GigaCore
ETHERNET SWITCHES

RELEASE NOTES

VERSION 3.0.2

Related products: GigaCore 10, 12, 14R, 16Xt, 16RFO, 26i

fig. 2

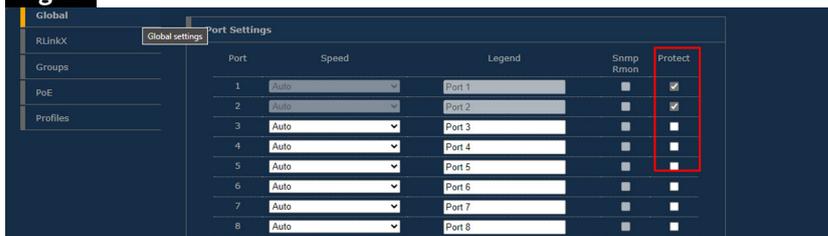
- PTPv2 E2E clocking is now enabled by default on all ports in all groups.
- WebUI:
 - Port protection feature has been added to prevent from accidentally selecting ports and changing their Group (VLAN) assignment. **[Fig 2]**
